Submission for the Port Botany Quayline Equalisation Significant Infrastructure Development SSI-79878464

I strongly oppose the Port Botany Quayline Equalisation Development, not because I object to the concept of the expansion itself, but because I believe the EIS is fundamentally and significantly flawed.

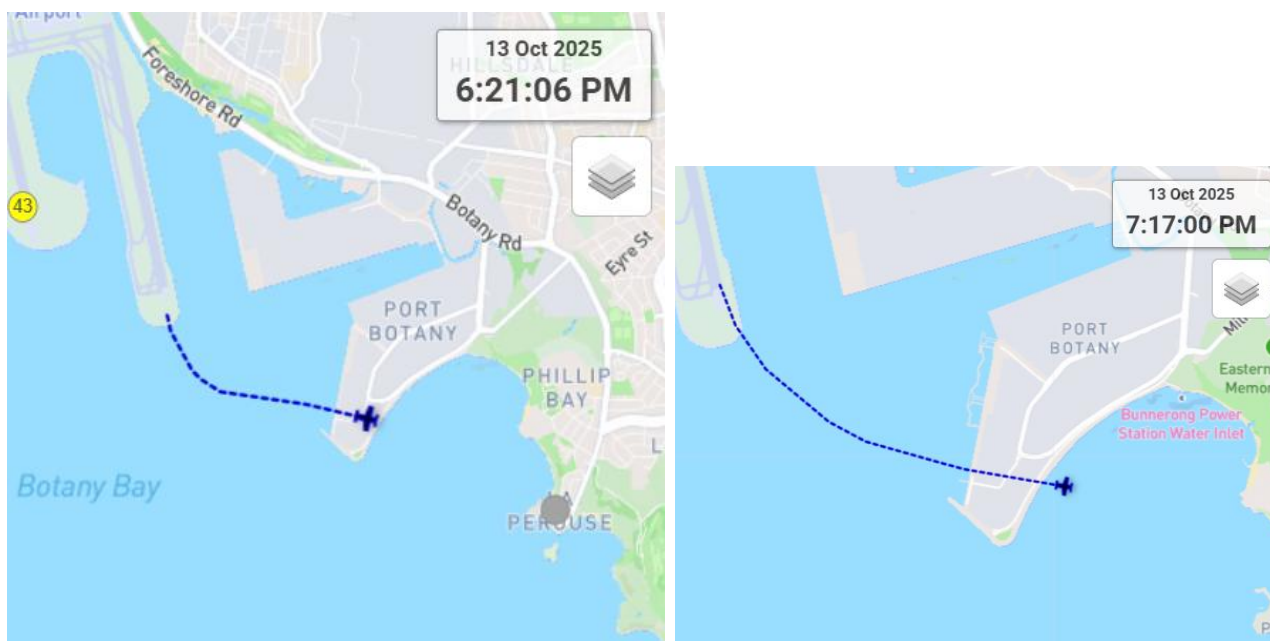
In the past hour that I have been writing this submission, two non-jet aircraft have over-flown the exact spot where BLB3 and the ships will be placed. (Images taken from Webtrak/Airservices publically available tracking system).

The images below of non-jet aircraft flying over the spot where BLB3 and its dangerous goods transfer ships will be located took place on 13 October 2025.

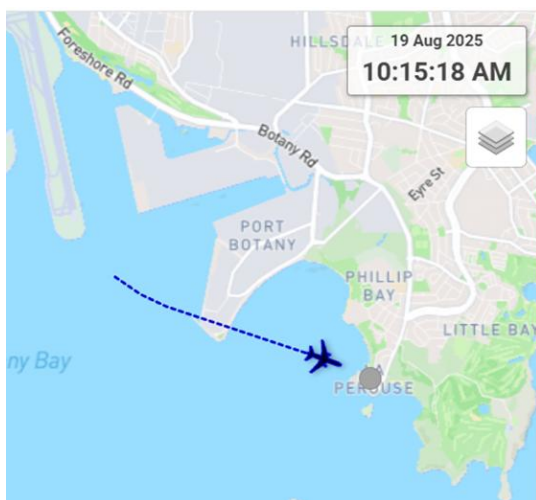
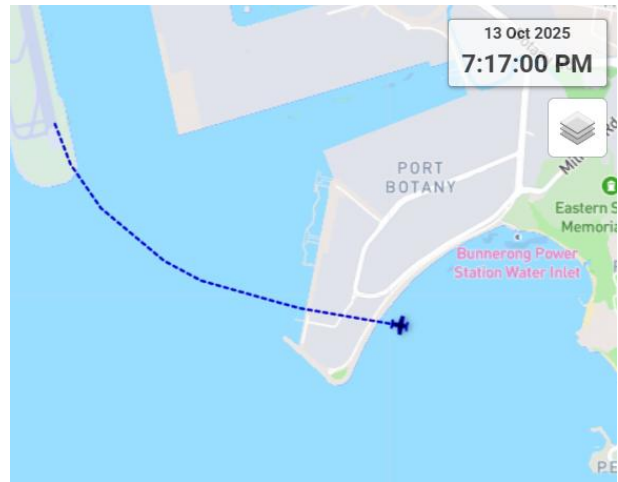
The fourth image included below was supplied to me within the last few years by Airservices. It clearly shows very large numbers of jets flying (evidenced by the swathe of green) over the Molineaux Point end of Port Botany, where BLB3 and the ships berthed off BLB3 will be located.

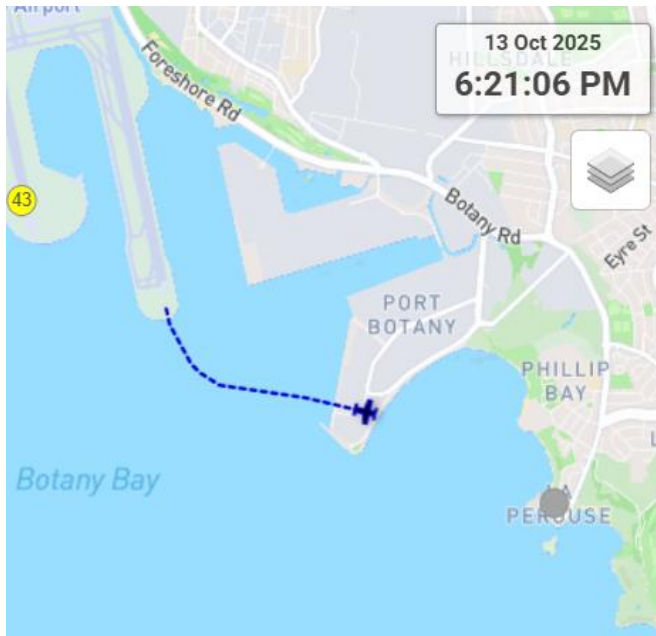
Image 1 & 2 below are excerpts taken from maps on p140 and p141 of 'Sydney Airport Master Plan 2045' document. These images were used by Sydney Airports to show the current flight paths in 2024. As you can see, Sydney Airports are clearly aware of the reality that both jet and non-jet aircraft overfly where BLB3 and its ships will be and they do not suggest that there will be any change before 2045. The third image provided by Airservices, indicates the very latest flight path (Kevin Seven) for a particular very short period of time. During this time very few jet aircraft flew over the BLB3 position, as evidenced by the few green lines, however multiple non-jet flights flew over BLB3 location as evidenced by the pink lines. BLB1 is shown to have zero aircraft over-flights. This confirms increased risk factor of aircraft crash from the BLB relocation.

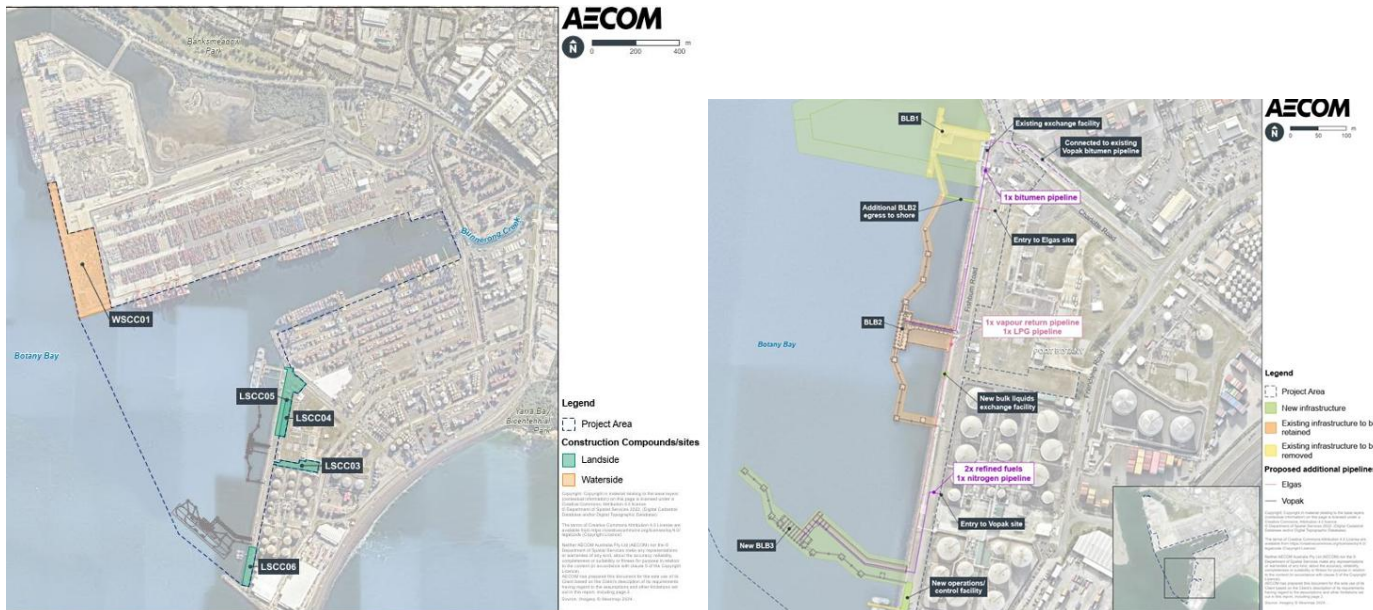
Two excerpts from images in the EIS, produced by AECOM, show (at the bottom of the image) the BLB3 berthing structures extending approximately 300m out over water from Port Botany towards the airport runway.

Figure 3-3 Assessment trigger area contours (windshear and turbulence)

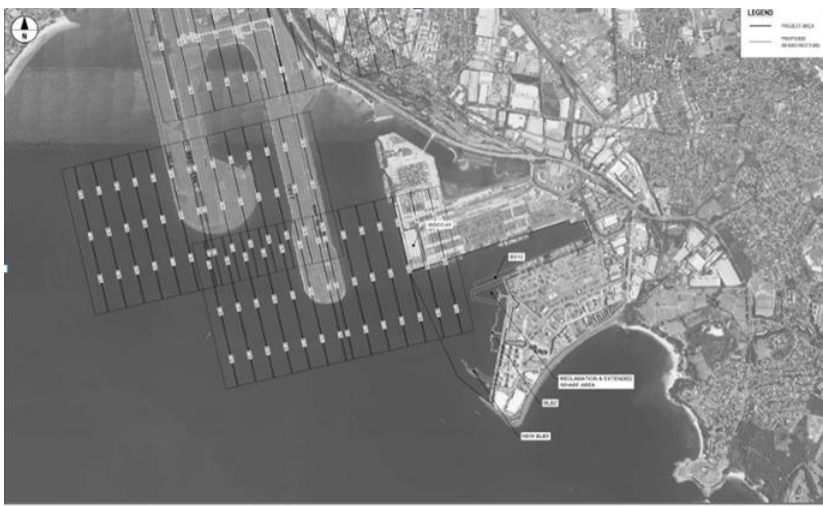
- Aviation risk from windshear and air turbulence.** Due to the size of these ships, even if they don't intrude into the Airports designated Obstacle Limitation Surfaces (OLS), or the PANS-OPS, which are mentioned in the report but not clearly explained, they may have the potential to affect wind and cause windshear and turbulence due to their proximity not just to the end of the runway, but to the departures pathway of aircraft. This issue, which is clearly an extremely dangerous possible impact for aircraft departing South from the 3rd runway (16L), is not addressed.

Images below shows trigger area for windshear and turbulence and PANS-OPS. As ships are not shown moored at the end of BLB3 in the windshear image (which would appear to be a gross oversight), it is not clear whether ships unloading their dangerous cargo at BLB3 could intrude within this area. Certainly, they would be right on the edge of this area if not within. The PANS-OPS image appears to have the BLB3 structures and ships intruding into the PANS-OPS area.

Figure 13-1 Social locality applied to the assessment of the Project

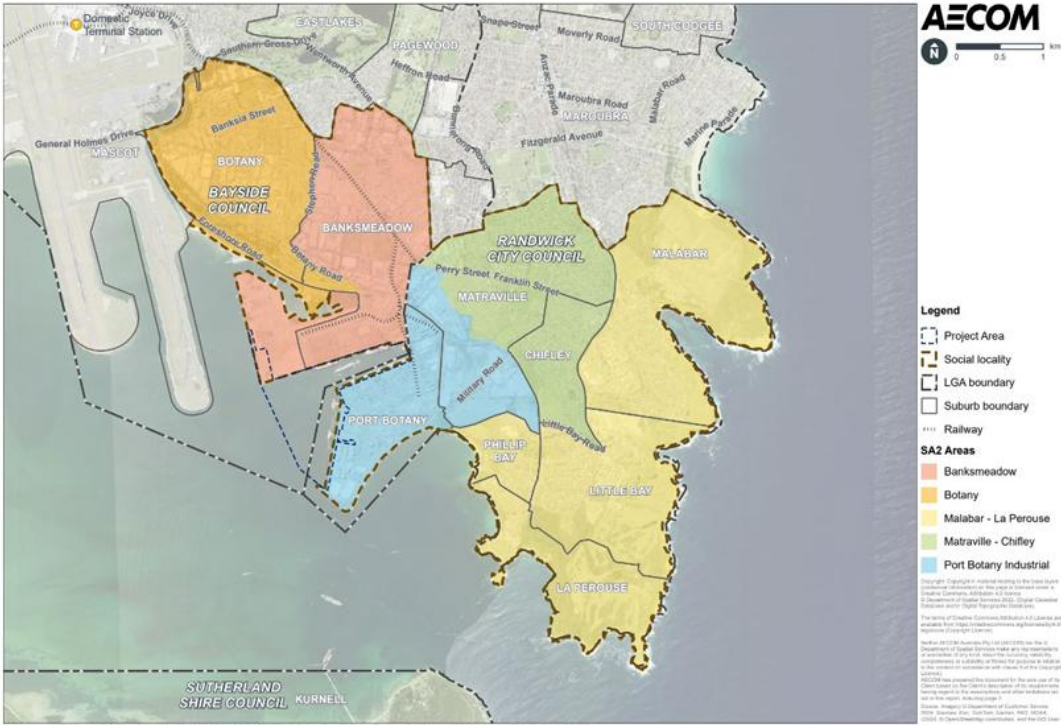
Concerningly, it appears that this ‘at risk’ group has not been addressed or assessed, as the beach has not been recognized as a beach in this report. This is deeply concerning and a major omission and doesn’t meet SEARS in terms of assessment of risk.

It should be noted that the social locality of the ‘proximal area’ (area closest to and most likely to experience strongest and greatest impacts) from the project has not been appropriately identified in the text devoted to this matter. The locality of Phillip Bay (which includes the beach users of Yarra Bay), which is the area closest to the project has not been identified in the written identification of areas in the ‘proximal area.’ This would seem to be a considerable omission. Instead, Botany, Banksmeadow, Malabar, La Perouse, Matraville and Chifley are identified. In the map showing social locality applied to the assessment of the project, the community of La Perouse is inaccurately placed out at Cape Banks not on the shores of Frenchmans Bay where it should accurately be located. This is extremely misleading particularly in a map where you are considering local communities affected!
